FOR PERCOLATION TESTING AND SITE EVALUATION

Lot 27 Perc Cert Revision, 2/23/21

GREENBERRY SECTION II
GREENBERRY PRESERVATION PARCELS 'I', AND 'J', AND
NON-BUILDABLE BULK PARCEL 'K',
LOT # 26 AND 27, PARCEL 48, NON-BUILDABLE BULK PARCELS C AND G
TAX MAP 28, PARCEL 48, HOWARD COUNTY, MARYLAND
FIFTH ELECTION DISTRICT
REVISED PERCOLATION CERTIFICATION PLAN

GREENBERRY, SECTION II
LOTS 26 AND 27, NON-BUILDABLE PRESERVATION PARCELS 'I', AND 'J', AND NON-BUILDABLE BULK PARCEL 'K'.
TAX MAP 28, PARCEL 48, NON-BUILDABLE BULK PARCELS C AND G
HOWARD COUNTY, MARYLAND
FIFTH ELECTION DISTRICT
REVISED PERCOLATION TEST PLAN

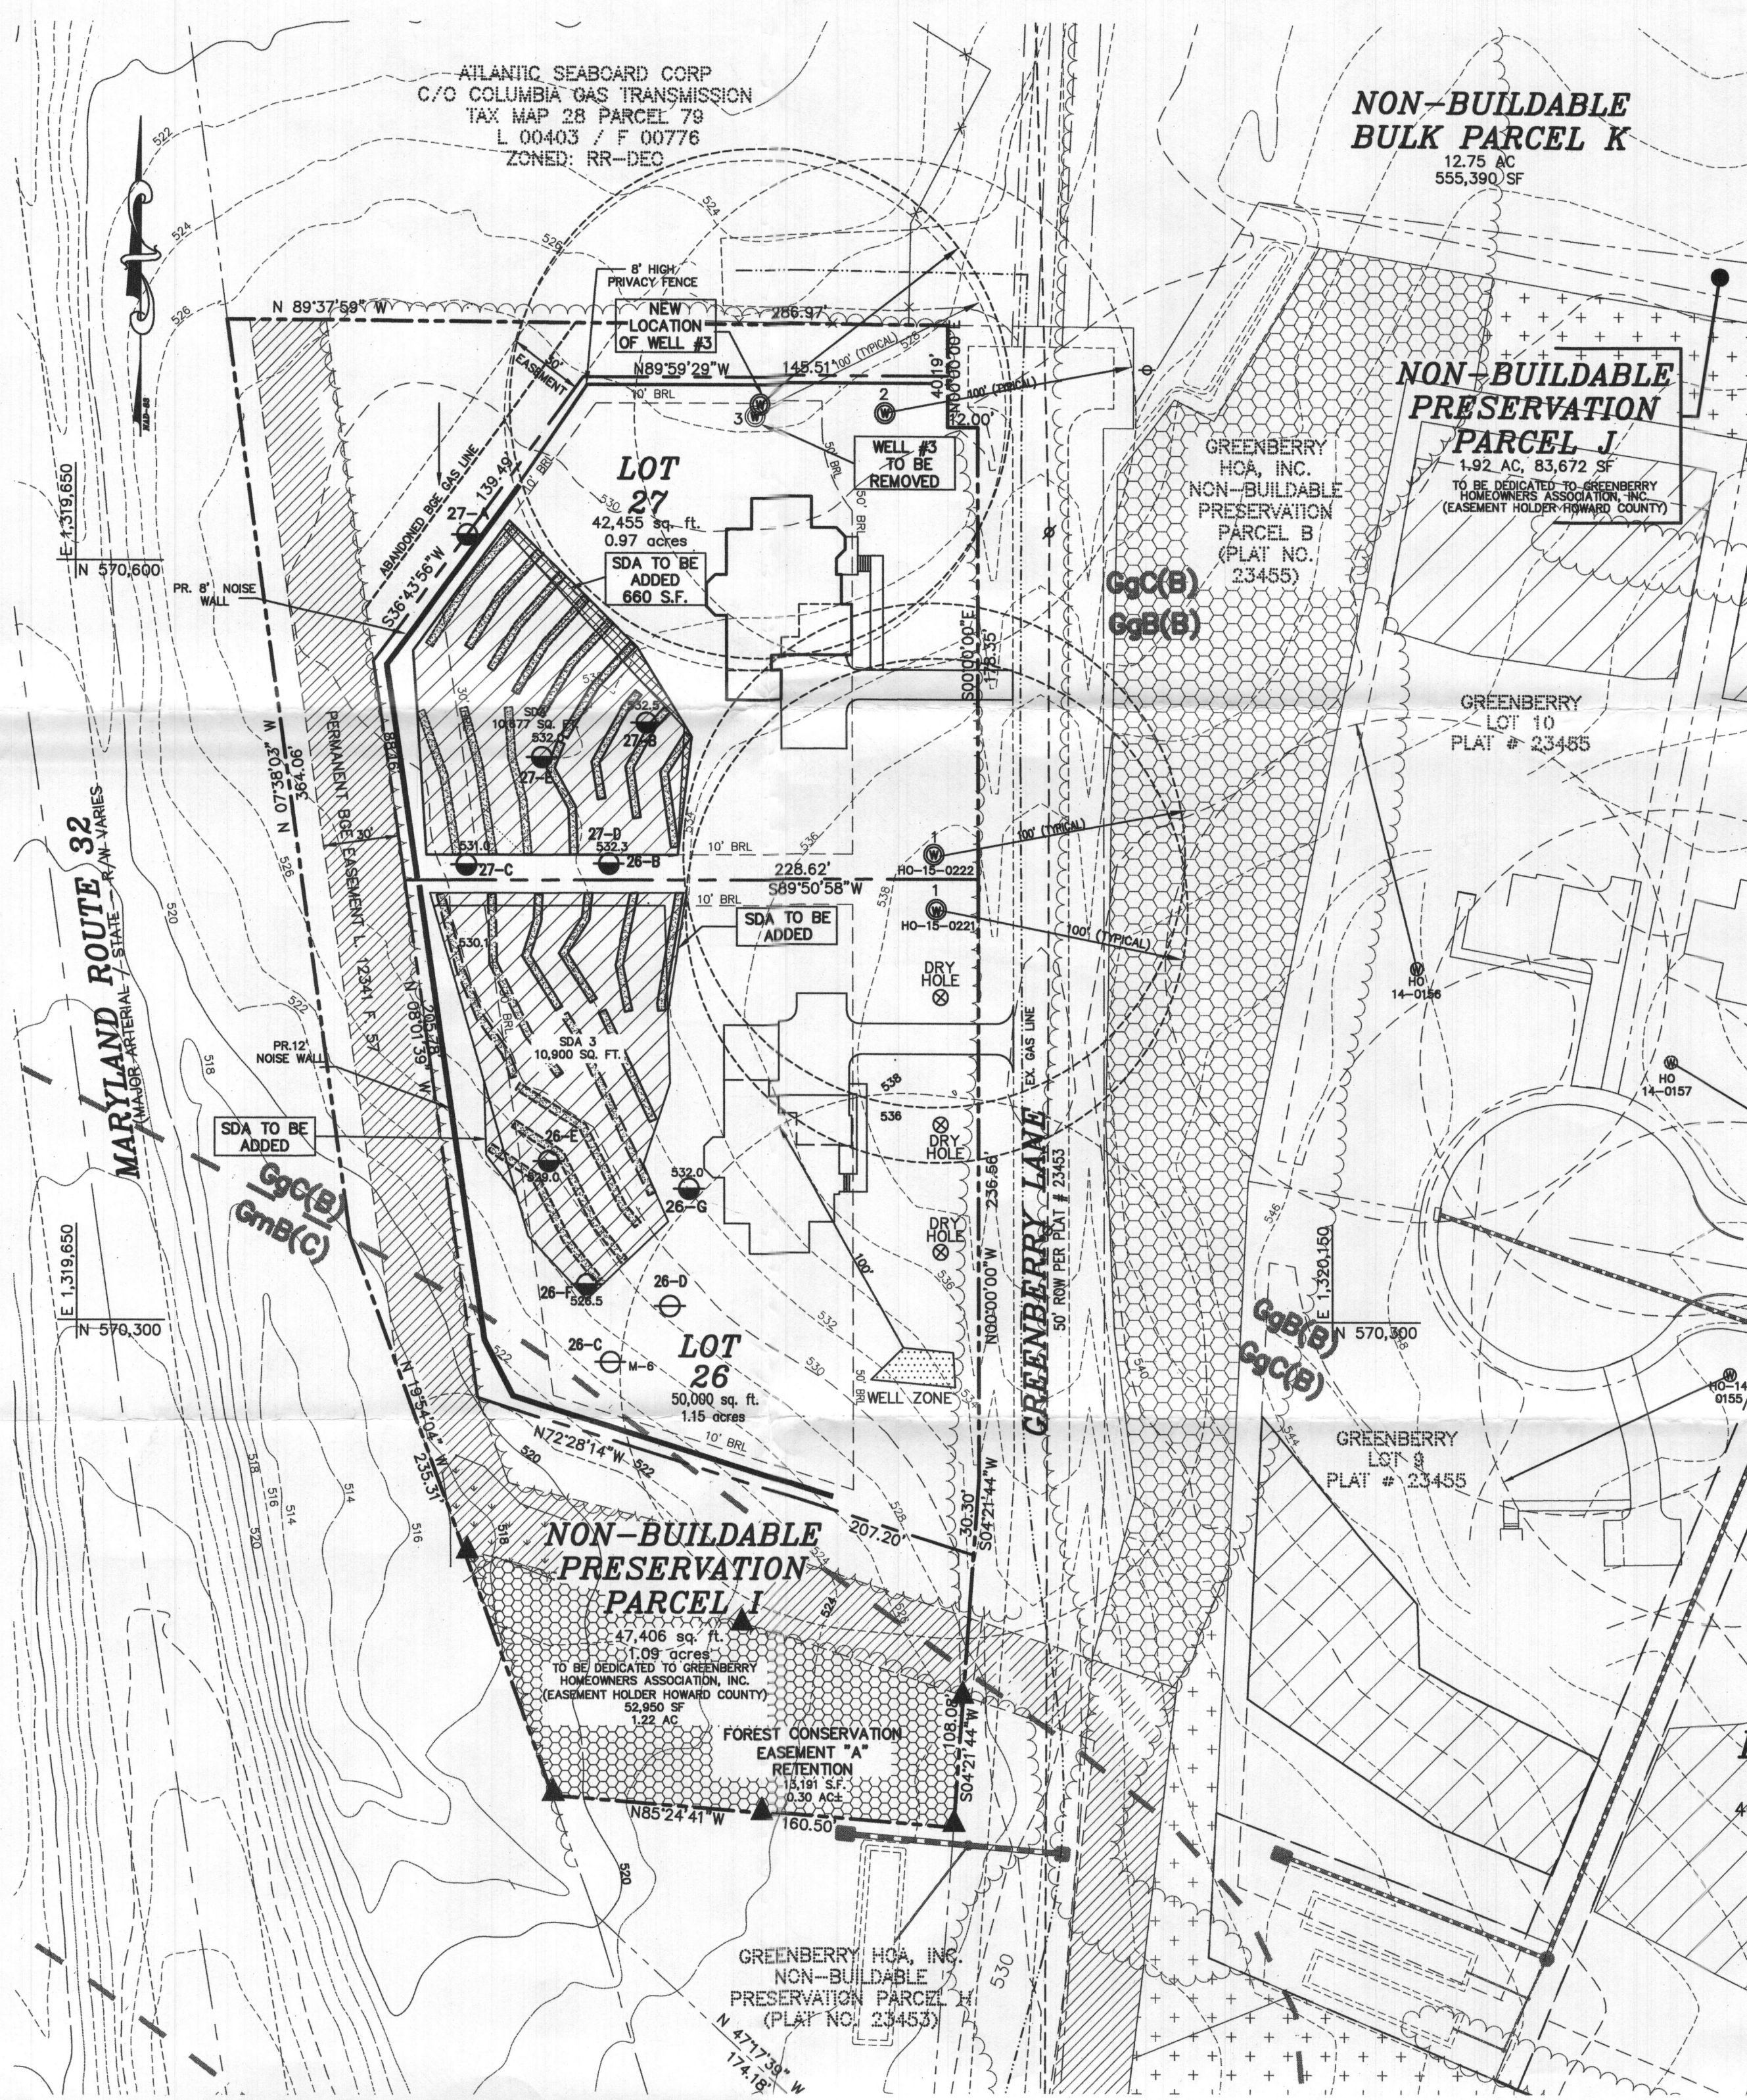
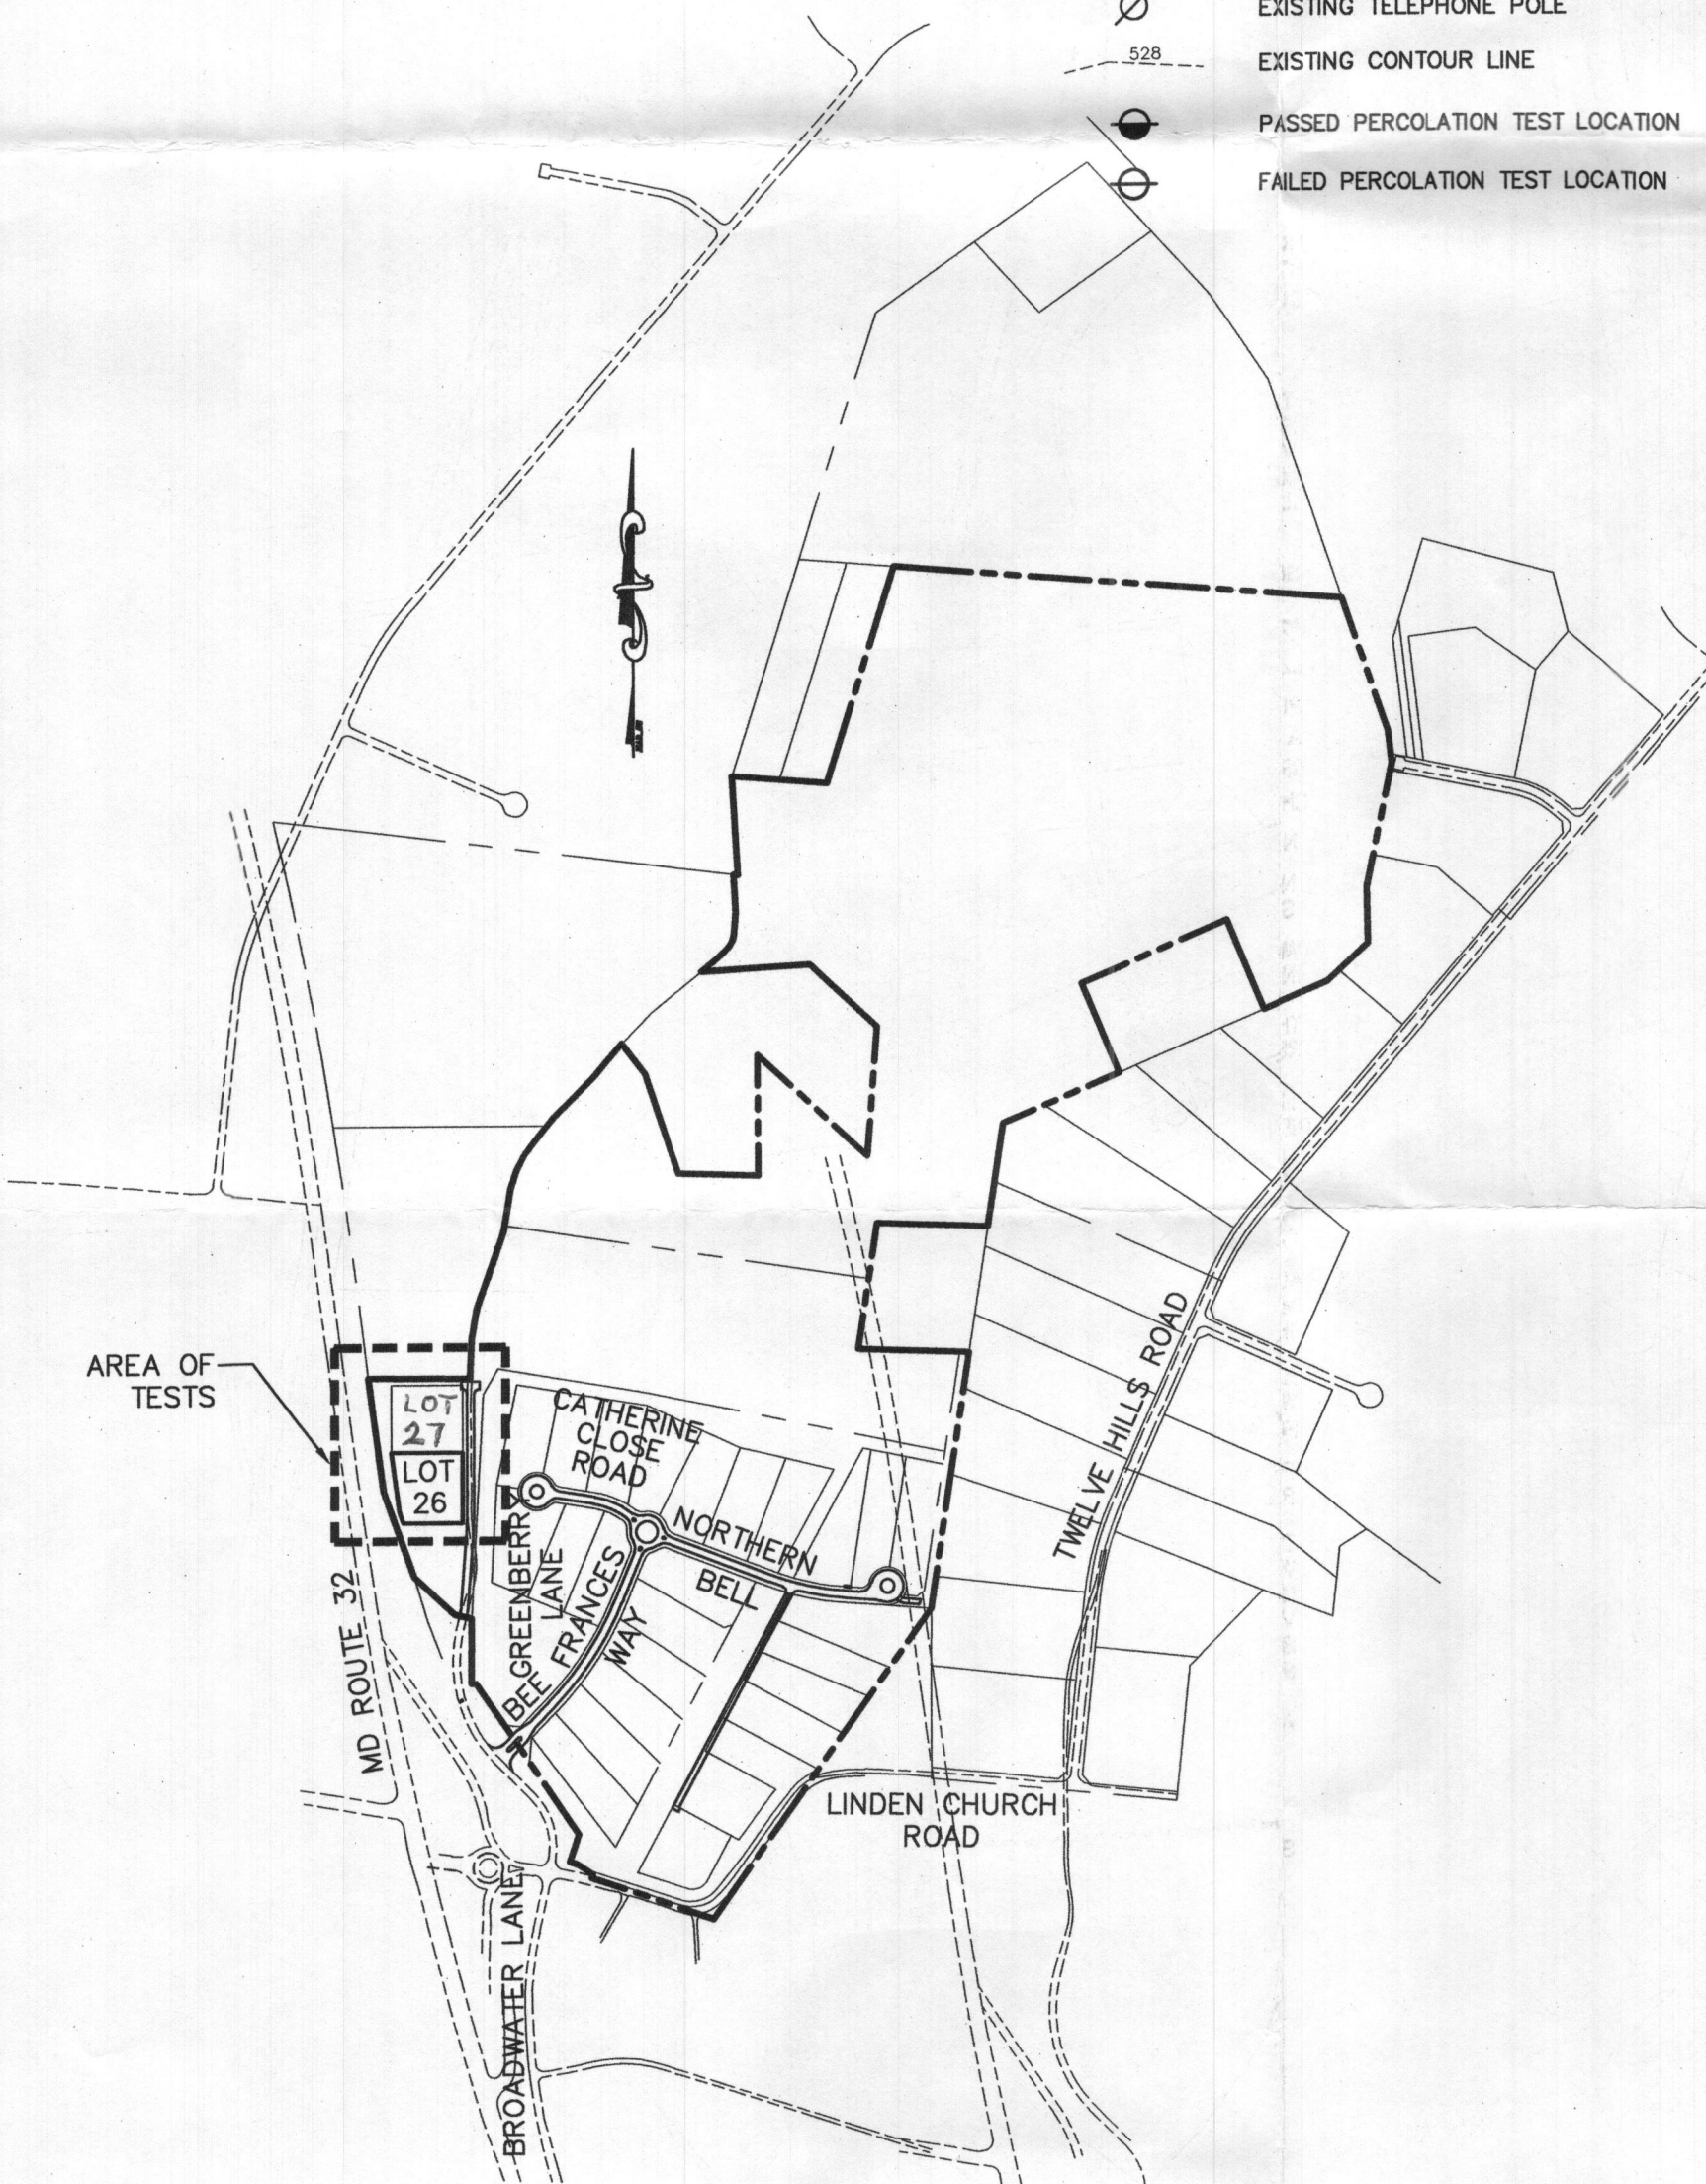
THE PURPOSE OF THIS REVISED PERC CERTIFICATION PLAN IS TO REVISE LOCATION OF WELL #3 AND RECONFIGURE SEWAGE DISPOSAL AREA ON LOT 27

date	9/20/2020	description	REVISED SDA TO ACCOMMODATE LONGER TRENCHES (TRENCHES SHOWN)
date		revisions
